Job 72430118REP1	Truss A1	Truss Type Truss	Qty 4	Ply 1	PBS\SMITHFIELD FC RH ROOF Job Reference (optional)
---------------------	-------------	---------------------	----------	----------	---

Repair to replace web 5-13 as shown.

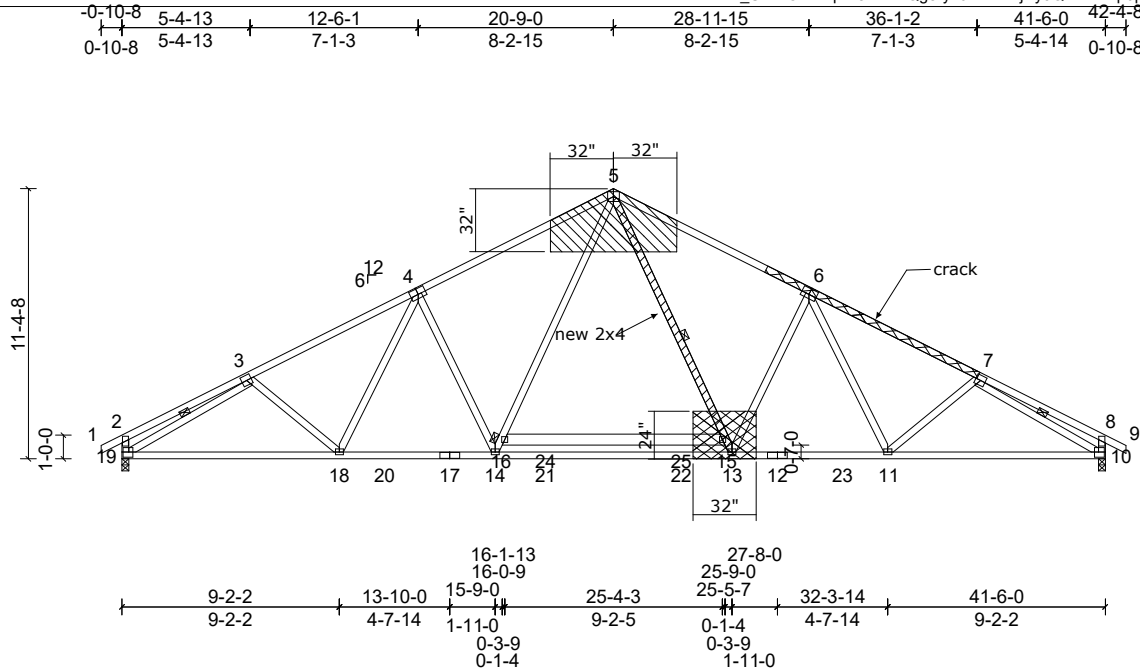
Repair for a crack in the top chord where indicated.

Cut and fit tight a new 2x4 SP or SPF No.2 as shown. attach 1/2" Plywood or 7/16" OSB (APA Rated Sheathing Exposure 1) gusset to both sides of truss as shown with two rows of 10d (.131" x 3") nails

Attach 2x4 x 10' SP or SPF No.2 scab to each face of truss centered on crack with 2 rows of 10d (.131" x 3") nails spaced 4" oc
